COMMUNITY MASTER PLAN

LEVEL B PLAN: AS APPROVED BY DEVELOPMENT REVIEW BOARD FEBRUARY 2008

AMENDED FEBRUARY 2024

Mesa del Sol

Figure 2-3

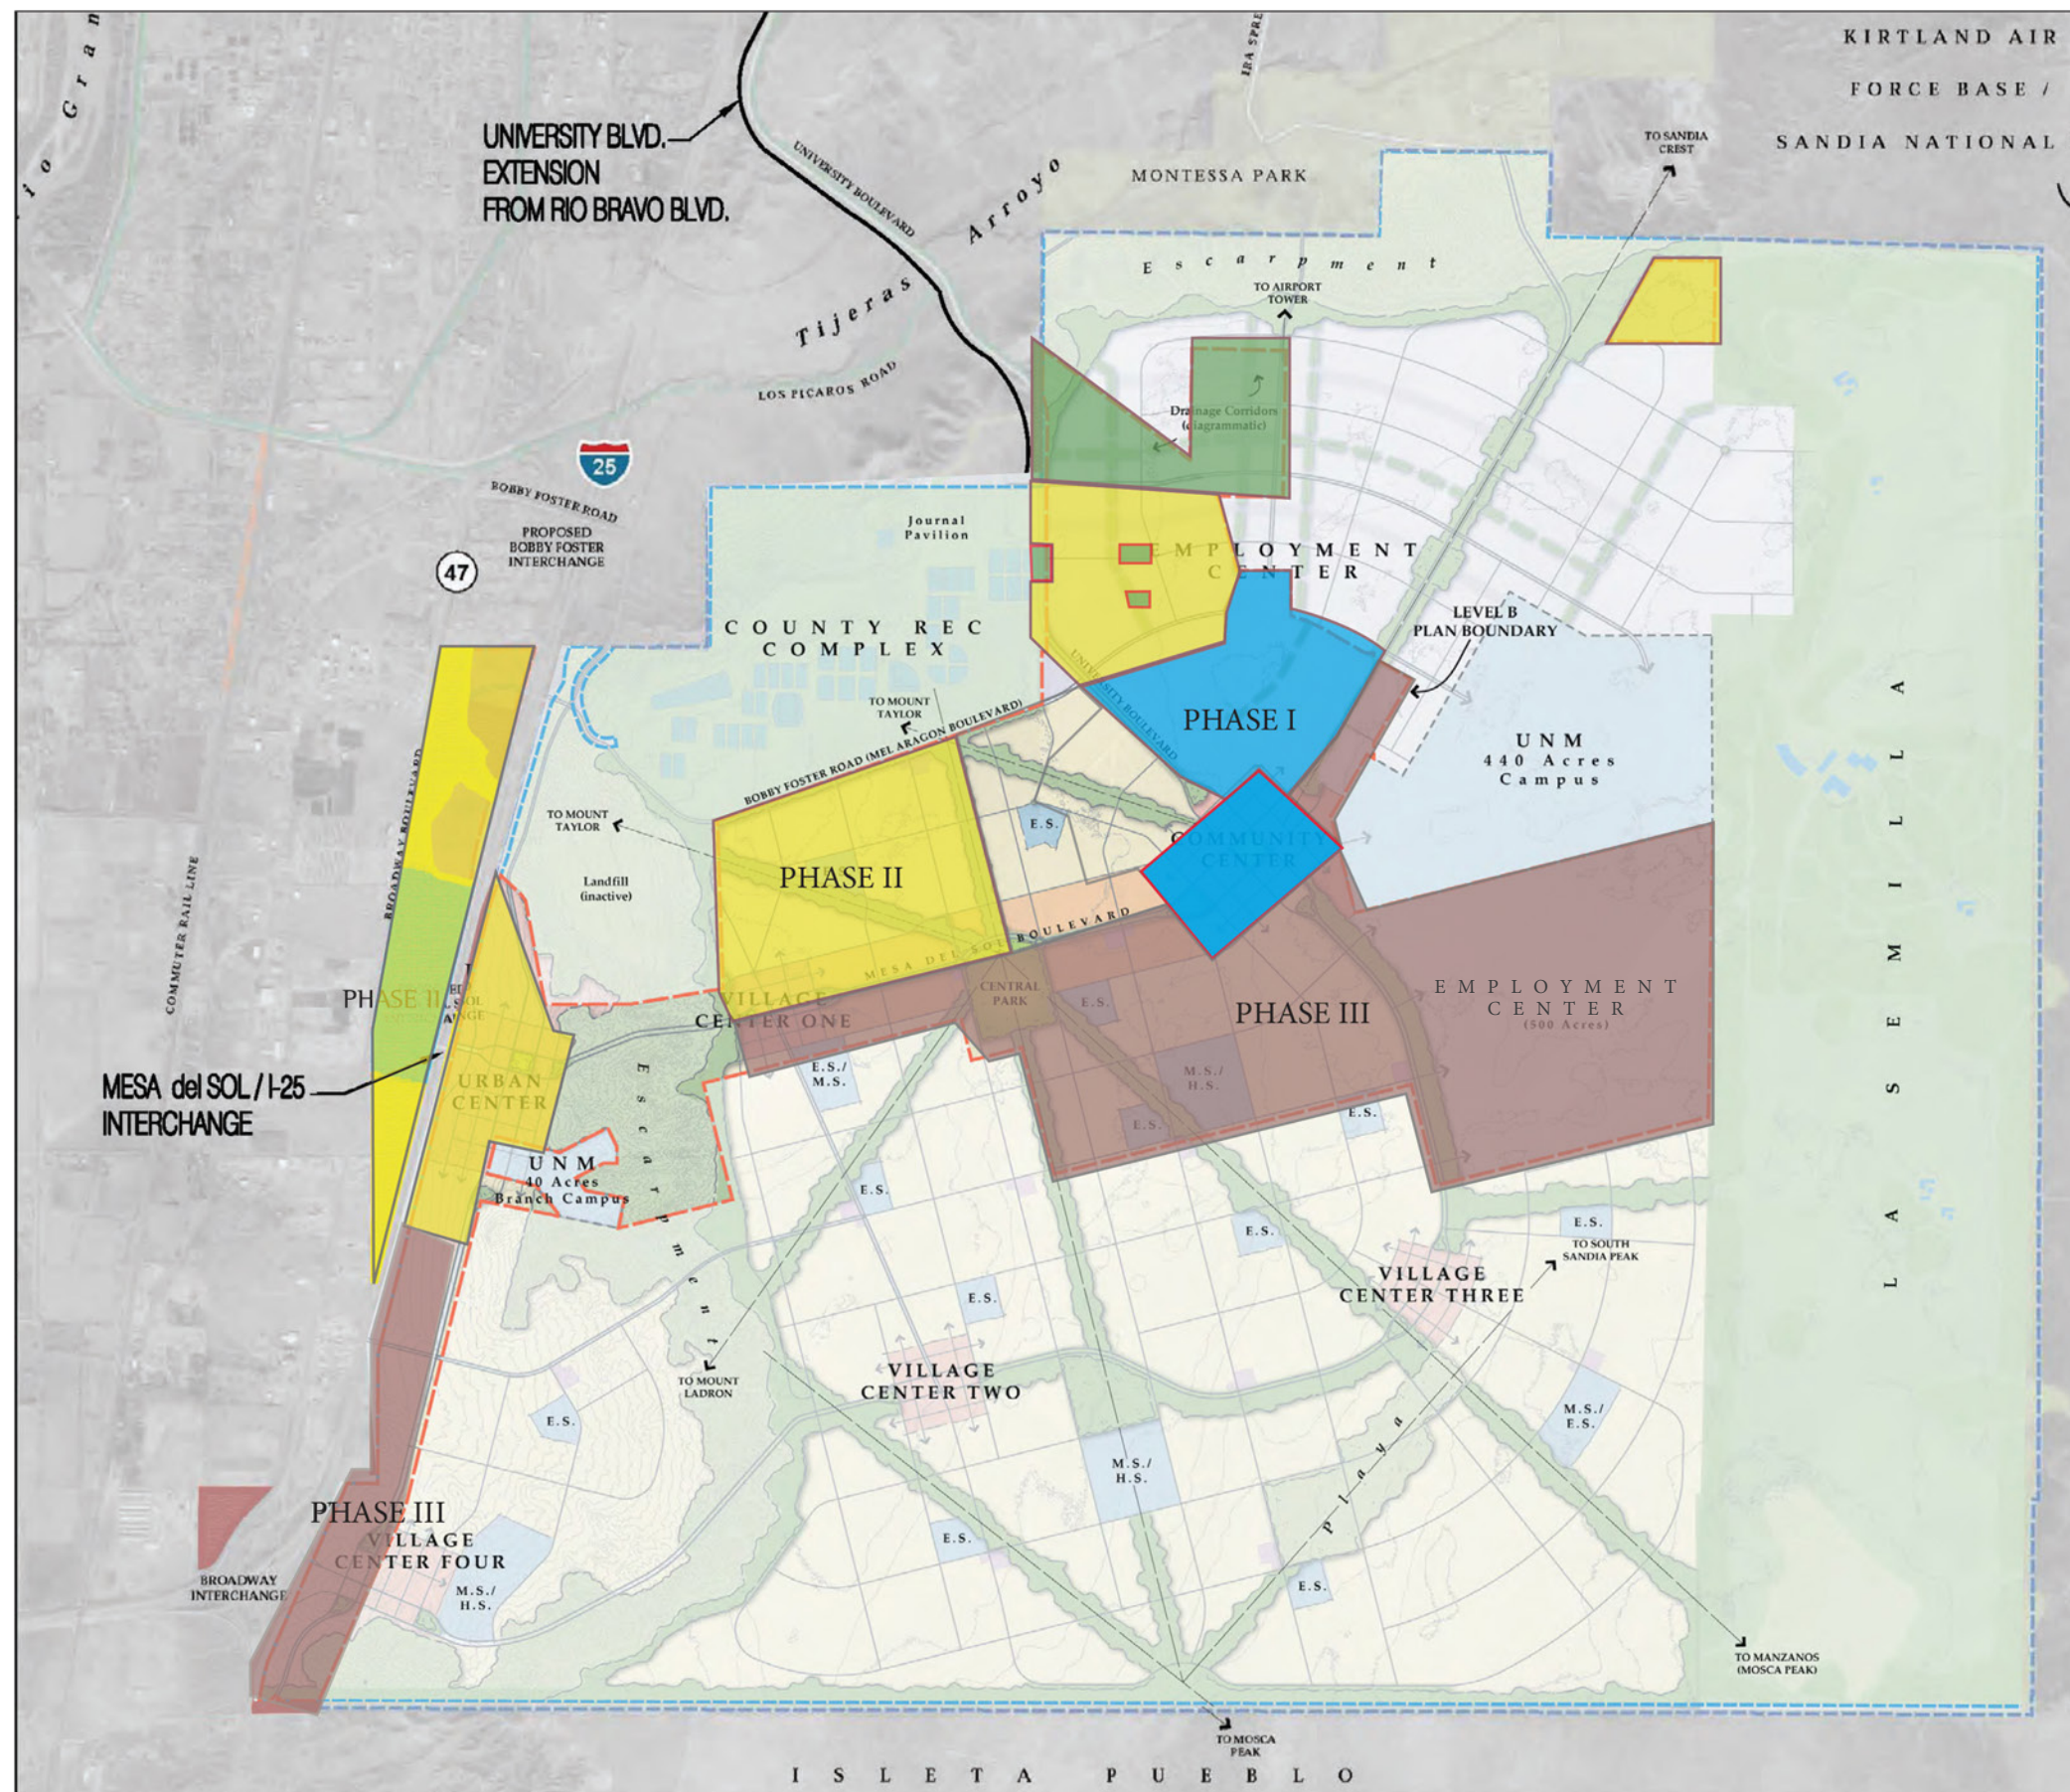
- Table 2.6-1 updated to show proposed responsibilities for Parks and Open Space to adjust acreages of Linear Park Corridors.
- Figure 2-3 reflects updates the Level B Overall Phasing Plan. Level B boundary and range of dates for phasing.

- Figure 2-3 base map was updated to reflect employment rather than residential
- Section 2.7 was updated to remove text referencing ‘active adult community’

Figure 3-5

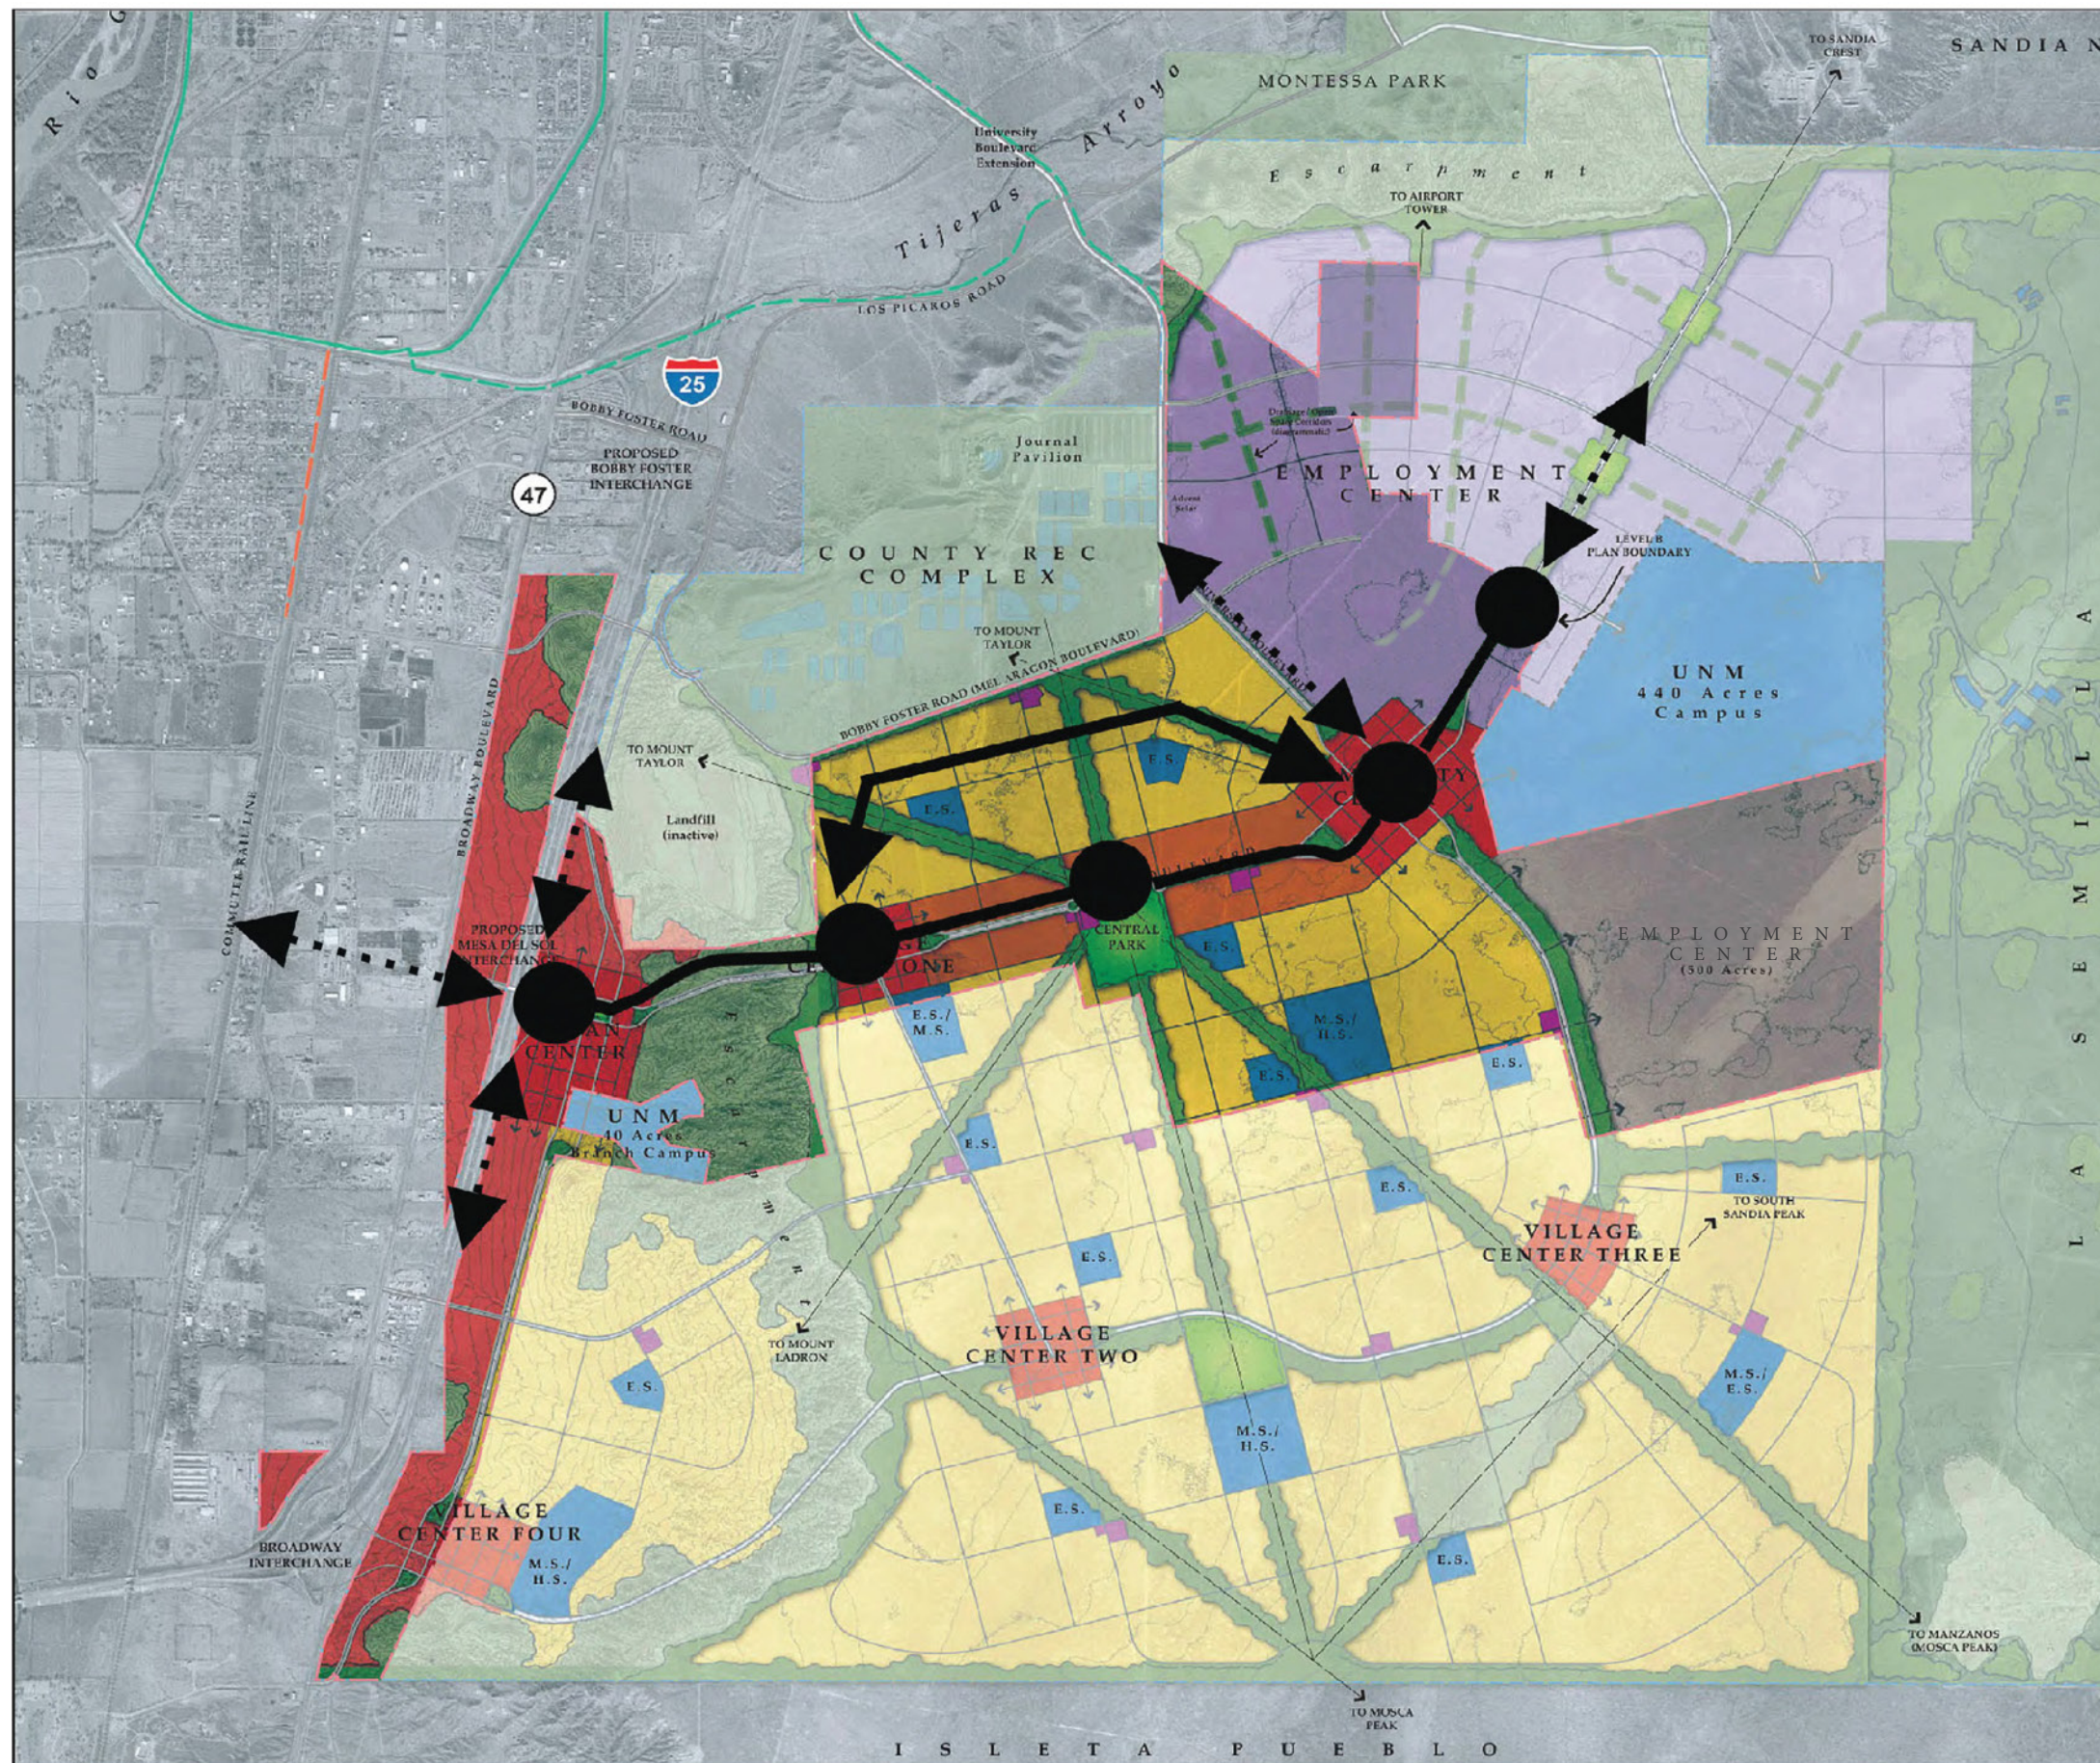
- Figure 3-5 updates to Transit System figure and adjust Level B boundary, roadways, and drainage. Additional language was added to summarize the modification.

- Figure 3-5 base map was updated to reflect employment rather than residential
- Figure 3-6 base map was updated to reflect employment rather than residential

Figure 3-6

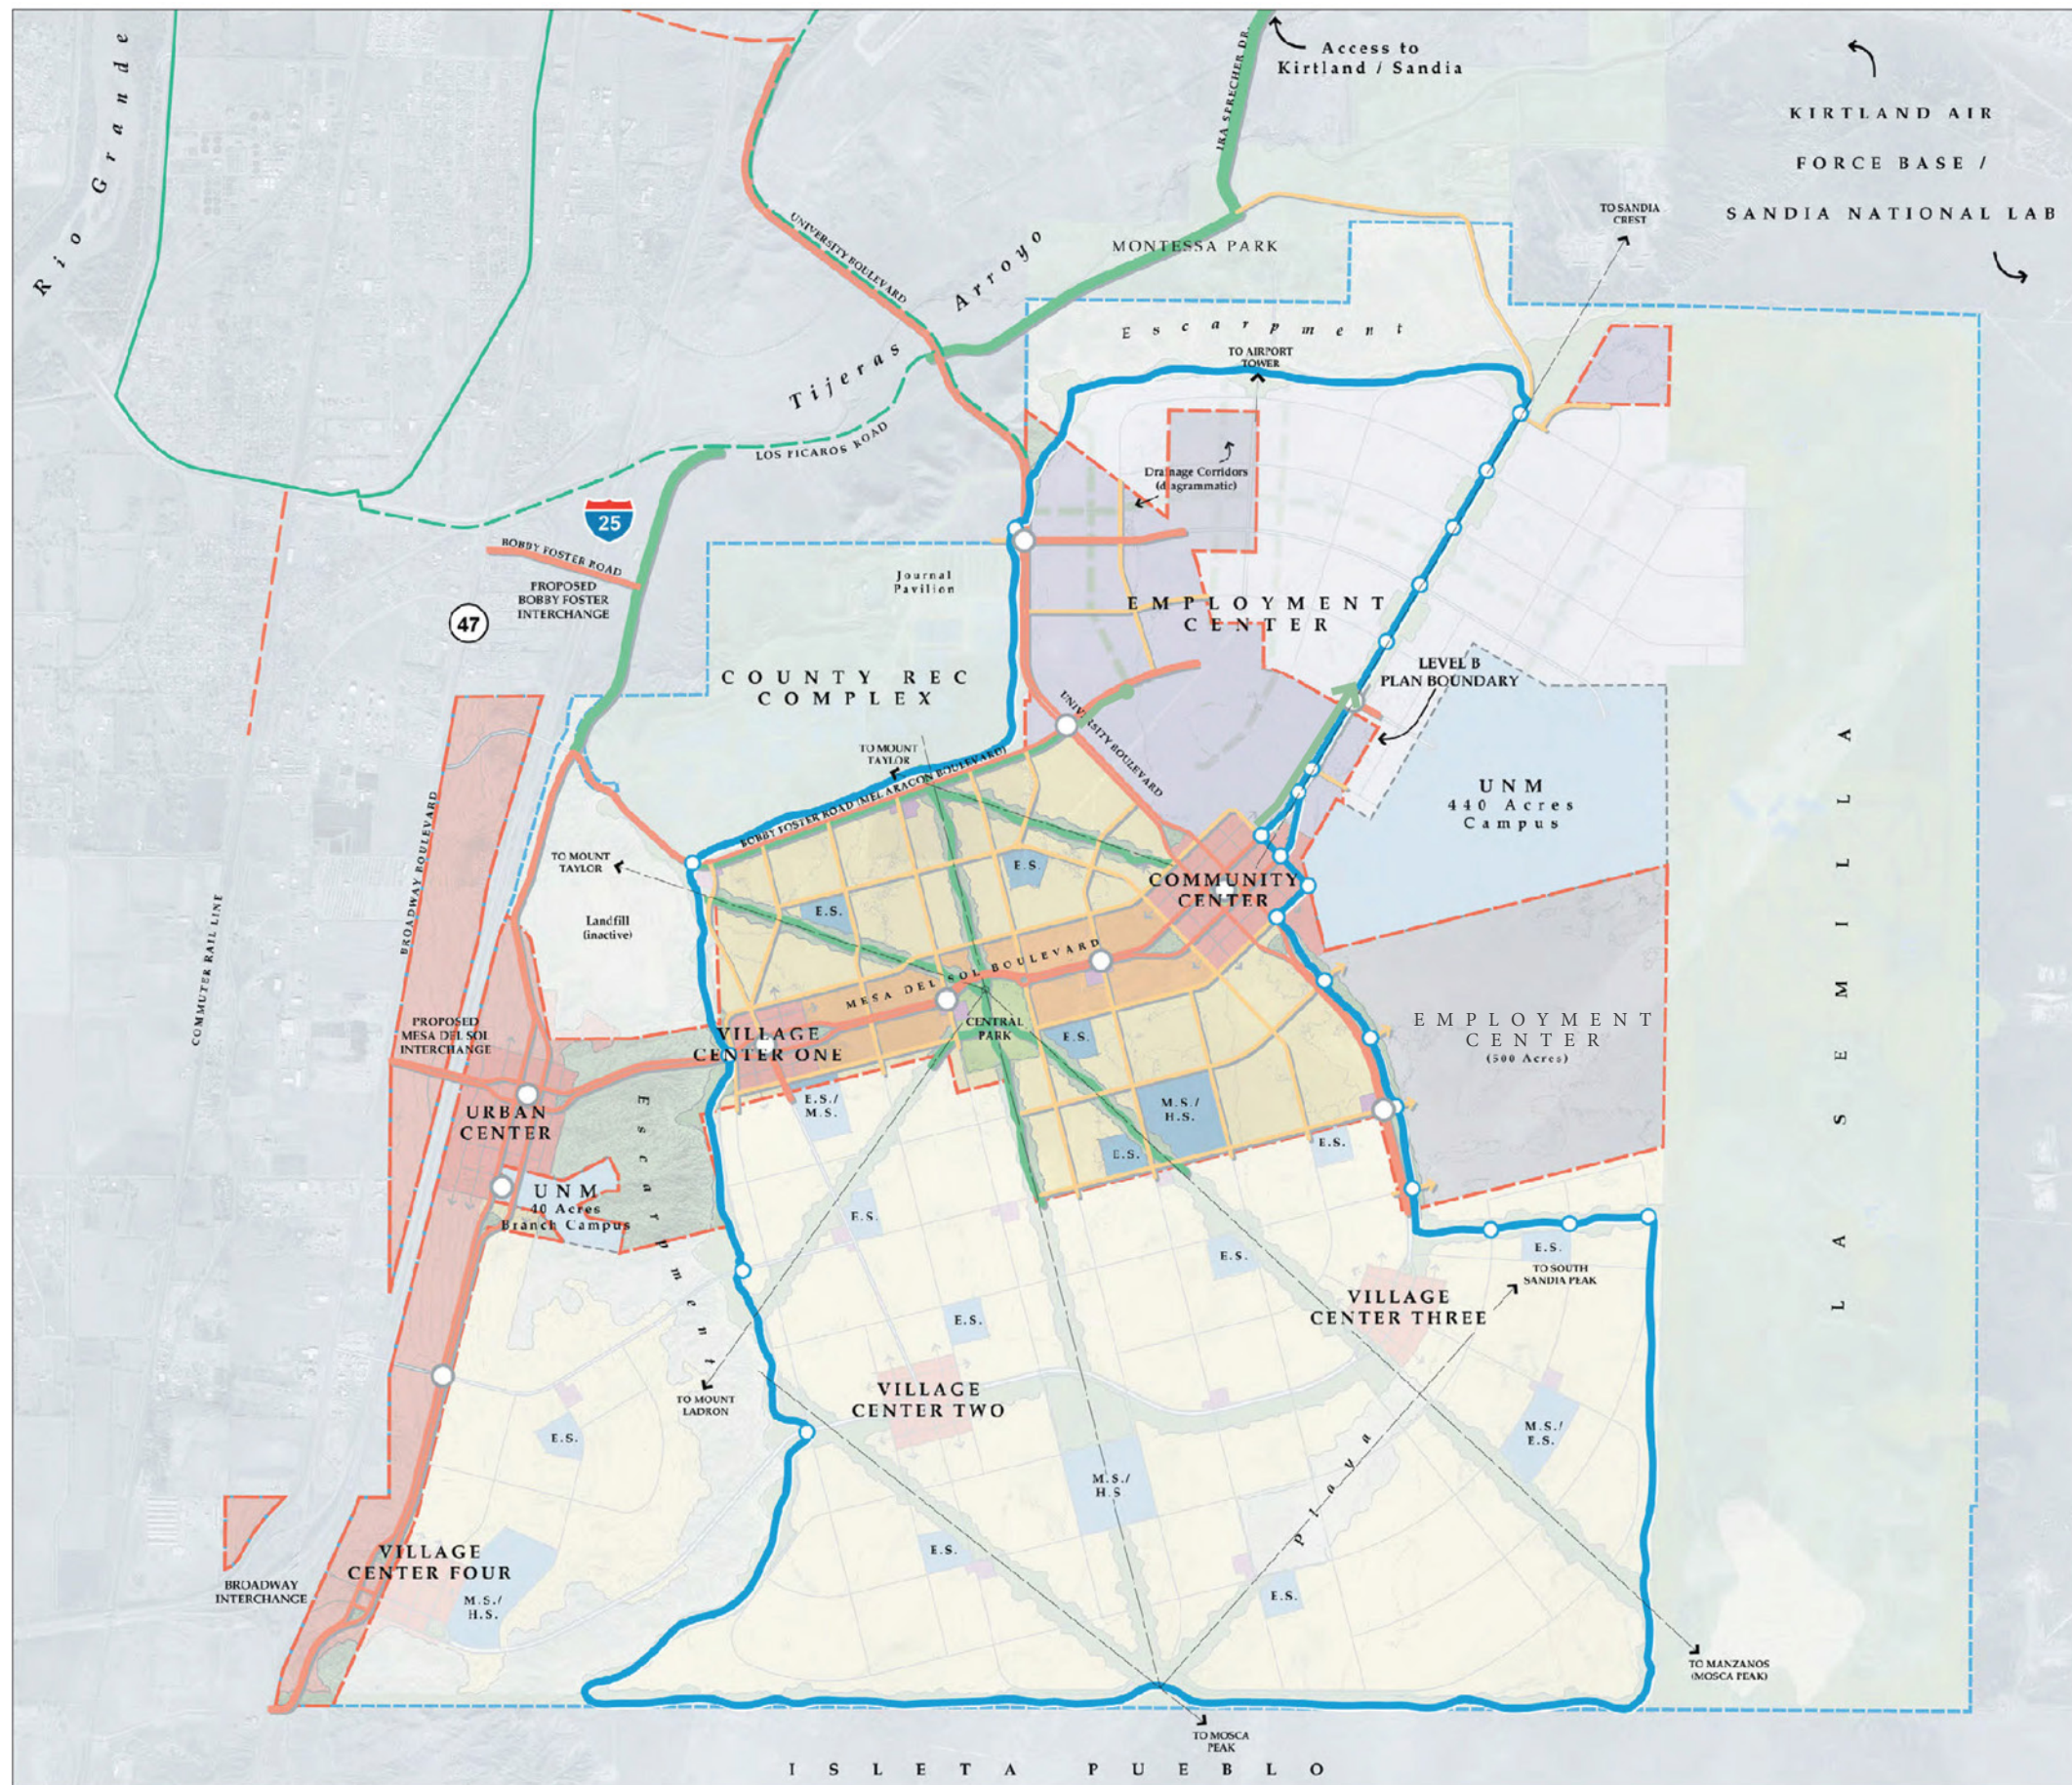
- Figure 3-6 updated Pedestrian and Bicycle Circulation to remove roadways, bike lanes and linear park / drainage corridors.
- Figure 4-4 updated Overall Stormwater Plan with revised approach for project area including remove/re-route DRIP system and ID pond location(s).
